U.S. Department of the Interior BUREAU OF LAND MANAGEMENT Sundry Print Report

Sundry ID: 2642613

Type of Action: Plug and Abandonment

Well: Serendipity 4

P&A Sketch dlj

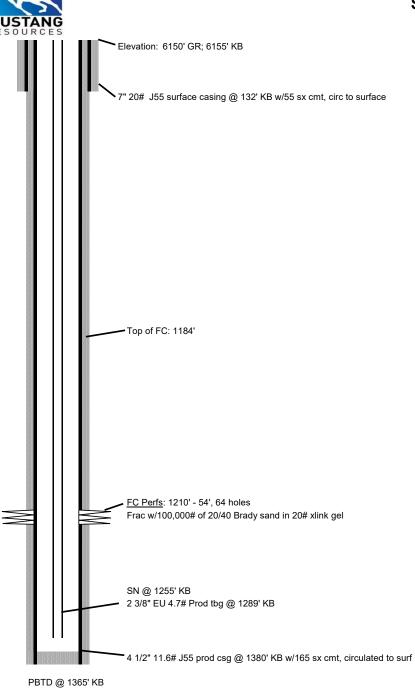
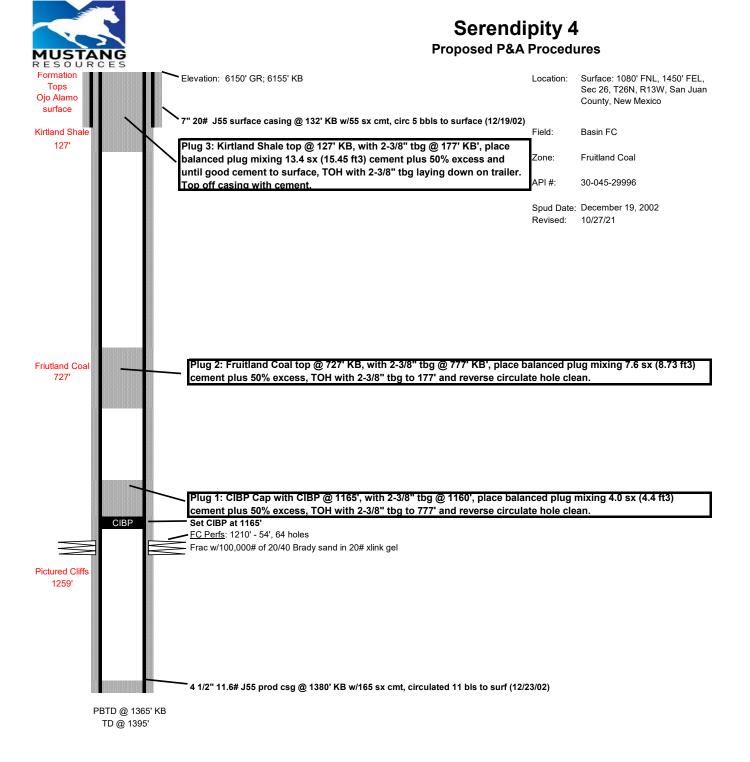
- Add a plug to cover the Pictured Cliffs top at 1254'.
- The plugs proposed in the P&A procedure, with changes as recommended above, will adequately protect any freshwater sands in this well bore.
- Fruitland perfs 1210' 1254'.

- 1. Plugging operations authorized are subject to the attached "General Requirements for Permanent Abandonment of Wells on Federal and Indian Lease."
- 2. Farmington Office is to be notified at least 24 hours before the plugging operations commence (505) 564-7750.
- 3. Before or within 30 days after completing work, Mustang Resources LLC must contact a Farmington Field Office surface inspection staff to schedule a reclamation onsite.
- 4. The following modifications to your plugging program are to be made:
 - a) Add a plug to cover the Picture Cliffs formation top at 1254 feet.
